Response to reviewers

Preprint wes-2025-41

Title: Scour variability across offshore wind farms (OWFs): Understanding site-specific scour drivers as a step towards assessing potential impacts on the marine environment

Referee # 2

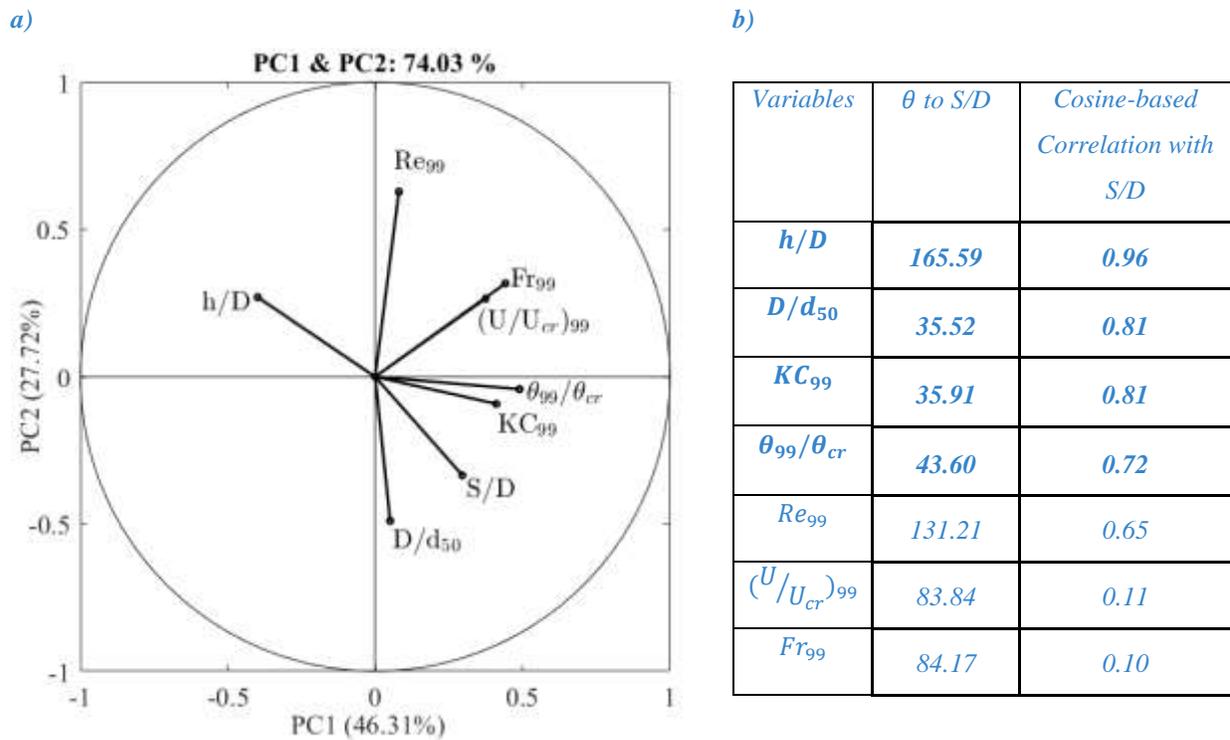
My specific concerns are on (i) the choice of a mix of dimensionless and dimensional parameters as the set of explaining parameters, (ii) the use of wave height instead of near-bed wave-induced orbital velocities, (iii) the background and limitations of the flow parameter ($U_{c,99}$) and (iv) the implication of the word “understanding” in the title. Please see my explanation below.

2. Choice of parameters: It strikes me that many but not all (five out of eight) variables are dimensionless. There seems to be some arbitrariness involved, which makes me wonder about the implications of that for the overall results and conclusions. Why did you decide not to scale the other three: wave height, current velocity and sediment size? From physics-based scaling arguments, I would always expect that dimensionless parameters provide the most meaningful way of explaining dependencies. Please clarify.

P14, Figure 4: Please state that these angles are presented in degrees and I do not see the added value of presenting so many digits. Suggest rounding off to degrees. I don’t think this really is a percentage (number between 0 and 100) but a number between 0 and 1. To my knowledge the value in the right column is the absolute value of the cosine of the angle in the middle column. And why some printed in boldface and others in regular typeface?

In response, we have made a new Principal Component Analysis (PCA) analysis that only considers dimensionless parameters. Dimensional parameters such as wave height (H_s) and current velocity (U) were removed from the direct PCA input. Additionally, median grain size (d_{50}) was transformed into a dimensionless relative roughness parameter (D/d_{50}), where D is the monopile diameter. Additionally, we have included the mobility parameter MOB (θ_{99}/θ_{cr}) and the Keulegan-Carpenter number (KC_{99}) into our PCA. Accordingly, Figure 4, in page 18 has been updated:

Lines 3368-410 (Page 18 -19), which describe the results from the PCA, have been modified:

“As shown in the biplot, PC1 and PC2 account for 74.03% of the variation in the data set. This high percentage indicates that these two components capture most of the significant patterns in the data, allowing for a meaningful interpretation of the relationships among the variables. In the biplot, each vector stands for a variable, with the direction and magnitude of the vector reflecting its contribution to the principal components. The variables that contribute the most to the variance in PC1 are the mobility parameter, the

Thanks to the reviewer for pointing this out. We have clarified in the caption that the angles are given in degrees. Furthermore, the column label "Correlation" has been specified as the cosine-based correlation with S/D. This metric reflects the strength of the correlation (ranging from 0 to 1), with values closer to 1 indicating stronger correlations. On the other hand, the boldface indicates the variables that have the strongest correlations with S/D. The caption of Figure 4, in page 18 has been modified:

“Figure 4: a) PCA biplot, illustrating the correlation between variables and relative scour depth. b) The table detailing the angles between the relative scour depth and the other variables (in degrees), along with the magnitude cosine-based correlation (values from 0 to 1), where values closer to 1 indicate stronger correlation.”

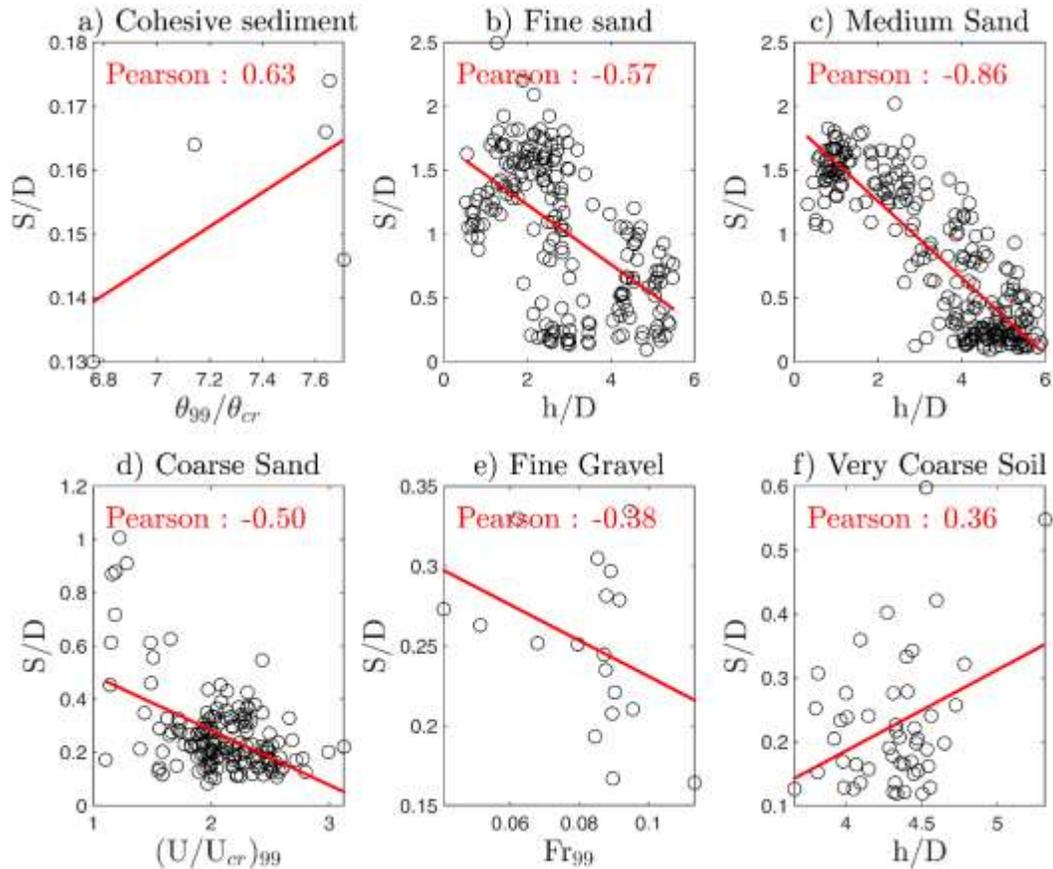
P19, Figure 6: Please be consistent in terminology: replace “normalised scour depth” with “relative scour depth”

Figure 6 (page 24), has also been updated to include only dimensionless parameters in the PCA for different soil classes:

Considering the small number of data points in this sediment cluster, relative scour depths (S/D) at locations with cohesive sediments (Fig. 6a) show a moderate positive correlation with the mobility parameter. For the fine and medium sand clusters, the PCA revealed a similarly strong dependence of scour depth on relative water depth. Plotting scour depths against relative water depths now shows a clearer

trend and hence dependence for the fine sand sites (Fig. 6b) than for the medium sand sites (Fig. 6c). The Pearson coefficients of -0.57 and -0.86 confirm this difference in the dependence of scour depth on relative water depth. The correlations of the fine and medium sand clusters are supported by a larger number of data points, increasing the reliability of the findings.

Figure 6, page 25 has been updated in the manuscript, and the terminology was simply established as h/D

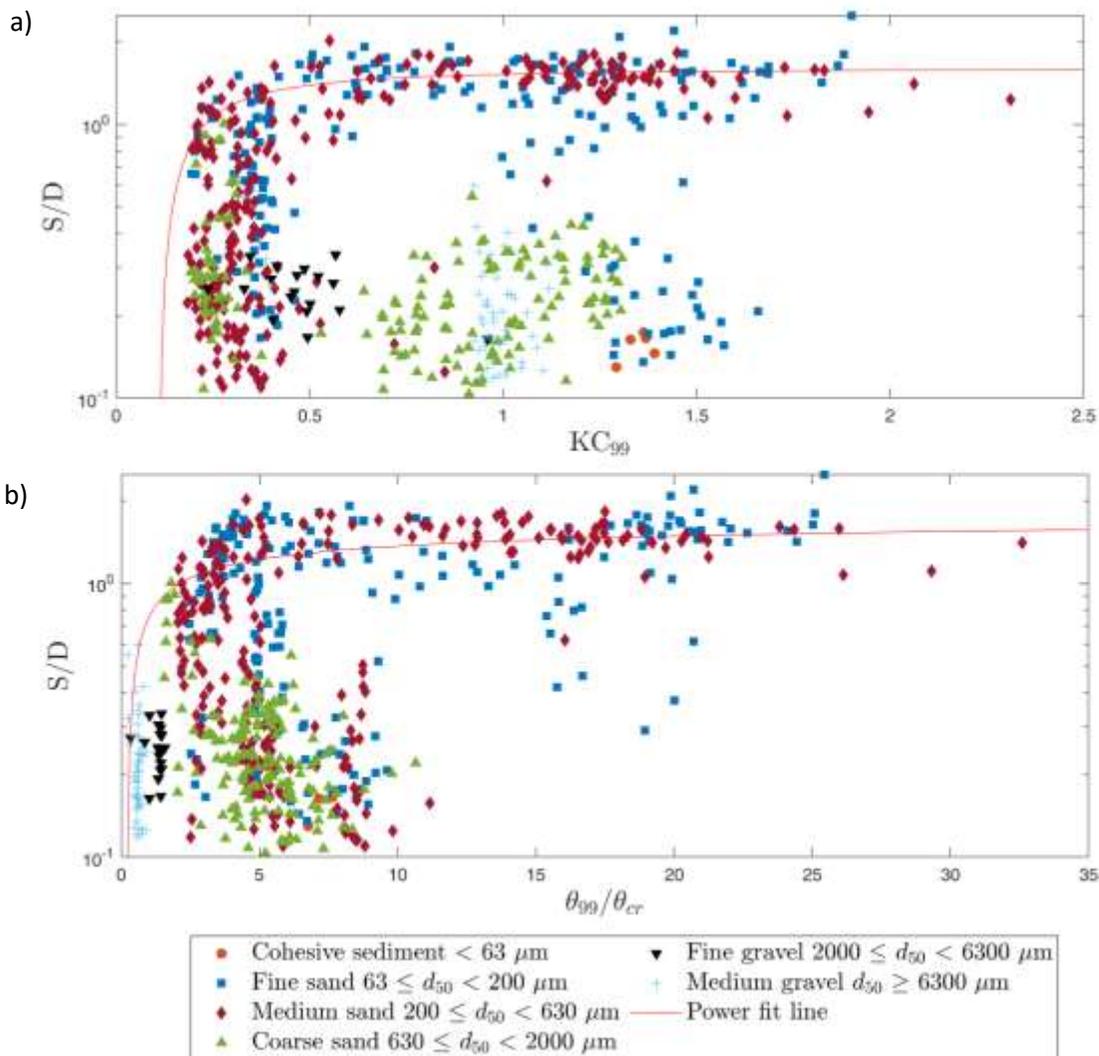
3. To me, it would seem logical to convert wave height (along with wave period, which is now overlooked) into near-bed wave-induced orbital velocities (using linear wave theory). This quantity is more directly related to scour. Please comment.

The third and fourth parameters, that correlate with the relative scour depth, are the Keulegan-Carpenter number and the mobility parameter as identified by the PCA. Figure 9a shows the correlation between relative scour depth and KC_{99} , revealing a distinct increase of relative scour depth with increasing KC_{99} up to $KC_{99} = 0.5$. Above this value, S/D shows little variation with further increase of KC_{99} , which reaches a maximum value of 2.5 in this field dataset. Those results are generally consistent with findings from previous studies (e.g., Qu et al., 2024; Sumer & Fredsøe, 2002), which indicate that scour development is strongly dependent on KC_{99} at lower values, but becomes less sensitive as KC_{99} increases. However, experimental studies often focus on wave regimes with KC numbers greater than 6, since it has been established that this is the threshold for generating a horseshoe vortex. Despite considering the 99th percentile of KC numbers over the time period in question, the KC numbers are much smaller for the field conditions presented herein. This strengthens the argument for further scour research to focus on boundary conditions with low KC values.

Figure 9b shows the correlation between relative scour depth and mobility parameter, comparing the Shields parameter with its critical threshold for sediment motion, and revealing a distinct increase of relative scour depth with increasing mobility parameter up to approximately $\theta_{99}/\theta_{cr} = 5$. At higher mobility values (typically above 5–10), the increase in scour depth tends to stabilize. This trend aligns with experimental observations from Sumer et al. (2013), Chiew (1984), and others, which describe similar stabilization of scour depth under fully mobile conditions. Notably, the response also varies with sediment type: coarser sediments exhibit low S/D values even at high mobility ratios, likely due to their higher resistance to entrainment and potential armoring effects. In contrast, finer sediments (e.g., $d_{50} < 200 \mu\text{m}$) show a steeper increase in scour depth, reflecting their greater susceptibility to hydrodynamic conditions.

KC_{99} has been calculated with the equation that was added in Table 2 on page 9. Furthermore, this parameter has been considered in the new PCA and can be found in the updated PCA in Figure 4 (page 18) as well as in Figure 9a (page 32).
